## MEMORANDUM ADDENDUM #3

TO: All Bidders  
FROM: Tracey Arena  
DATE: May 2, 2022  
RE: Village of Ardsley Contract No. VOA1811 New Public Works Facility

# **ADDENDUM NO. 3 dated May 2, 2022**

### **Contract No. VOA1811 New Public Works Facility**

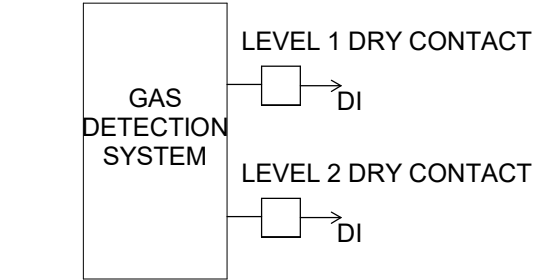
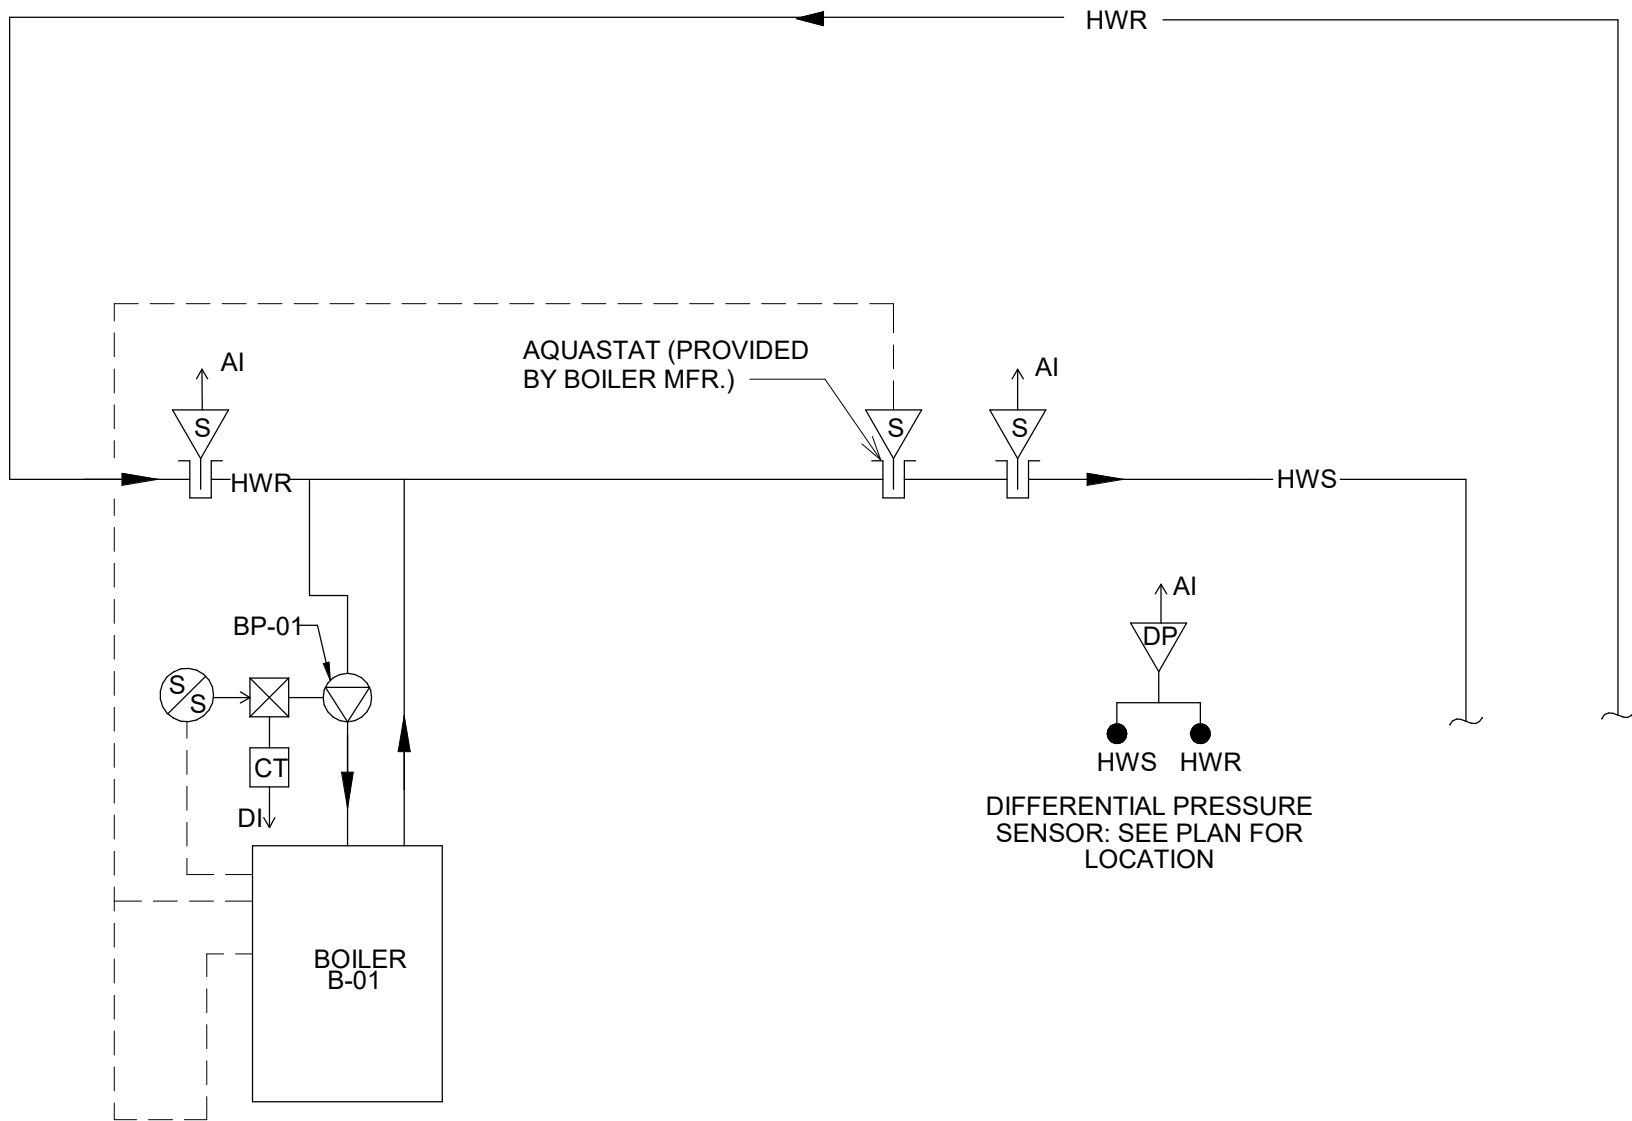
10. **QUESTION:** Please provide piping and connection detail route on drawing 1/P101 dated 4/7/22 in regard to addendum #2 clarifications chapter #3.

**RESPONSE:** Routing of the sleeves are between the Washbay Equipment Room #125 and the undercarriage wash trench drains. PC to coordinate with Washbay Equipment provider.
